E C O L O G I C A L R E V I E W

South Shore of The Pen Shoreline Protection and Marsh Creation

State No. BA-41

December 12, 2007

Figure 2. Design of the proposed rock dike, earthen containment dike, marsh fill, and interior borrow canal for marsh fill (NRCS 2007a).

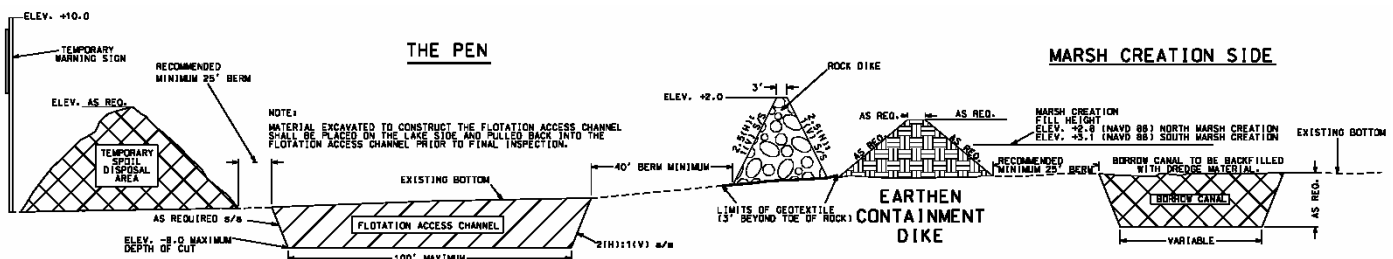
The curves provided for the projected settlement of the marsh platform over the 20 year project life indicate that the majority of the settlement (from an initial fill elevation of +2.78 feet NAVD 88 in the northern area and +3.1 feet NAVD 88 in the southern area to +1.3 feet NAVD 88) takes place less than one year after construction. Further, the straight line nature of the curves from year 2 through year 20 post-construction indicates that no settlement of the marsh platform will occur after year 2. While total settlement of the marsh platform over the project life is anticipated to be 1.48 feet in the northern area and 1.8 feet in the southern area, as detailed in the geotechnical report, the depiction of the settlement of the marsh platform as provided by the settlement curves seems unrealistic. Syed Khalil (Geologist, LDNR, personal communication, October 1, 2007) concurs with this opinion.

Ronnie Faulkner (NRCS, Project Engineer) received an email response on October 19, 2007, from Burns Cooley Dennis, Inc. (NRCS contractor for the geotechnical investigation) regarding the settlement curves provided in the Addendum Report on the Geotechnical Investigation for the South Shore of The Pen Shoreline Protection and Marsh Creation (BA-41) project. The email contained the following information related to the flat slopes of the settlement curves after the initial settlement occurs: “each data point shown on the plots through 20 years has a specific value associated with it that resulted from the model and although the lines appear to be horizontal in comparison to the early settlement, they actually have a very flat downward slope. It is also noteworthy that in all of these figures the changes in slope of the settlement curves occur near the normal water elevation for this site”.
